# HIGHWAY WORK PROPOSAL

Proposal Number: **007**

<u>COUNTY</u>	<u>STATE PROJECT</u>	<u>FEDERAL</u>	<u>PROJECT DESCRIPTION</u>	<u>HIGHWAY</u>
Waukesha	1060-10-71	N/A	IH 94 East West Freeway; CTH T and CTH Jj (B-67-240,245)	IH 094
Waukesha	1060-47-70	N/A	IH 94 East West Freeway; STH 83 to STH 16	IH 094
Waukesha	1330-47-71	N/A	C Delafield, State Road 83; Nagawaukee Park and Ride Lot	OFF SYS
Waukesha	2788-03-70	N/A	C Waukesha Meadowbrook Road; Rolling Ridge Dr to IH 94 EB Ramps	STH 318

**ADDENDUM  
REQUIRED  
ATTACHED AT BACK**

DETAIL FOR INSTALLATION OF CULVERT PIPES  
 IH 94 CULVERT CROSSING

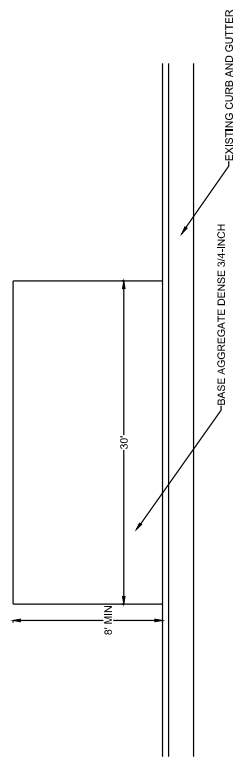
<b>Revised Plan Sheets 1060-47-70</b>	
Plan Sheet	Plan Sheet Title (brief description of changes to sheet)
33	Construction Details – Detail for Installation of Culvert Pipes (Revised backfill material and temporary patch material)
315	Miscellaneous Quantities (Revised bid items Backfill Granular Grade 1 and Base Aggregate Dense 1 1/4-Inch for the cross culverts)
316	Miscellaneous Quantities (Revised bid items Tack Coat and Asphaltic Surface Temporary for the cross culverts)
346	Miscellaneous Quantities (Removed the bid item for Backfill Slurry)
773K	Structure S-67-420 General Notes & Design Data (Revised quantity for Foundation Two-Shaft Type FF-II (structure) 001. S-67-420)

- NOTES
- 1) \*ASSUME TRENCH BOX WILL BE USED
  - 2) 1.5:1 SLOPES ARE REQUIRED FOR OPEN TRENCH.
  - 3) LOCATION TO BE BASE PATCHED WITH SHES CONCRETE PRIOR TO MILL & OVERLAY OPERATIONS
  - 4) BOTTOM OF BASE PATCH TO MATCH BOTTOM OF EXISTING CONCRETE PAVEMENT
  - 5) HMA AND BASE AGGREGATE REMOVAL TO BE PAID AS REMOVING PAVEMENT FOR BASE PATCHING.
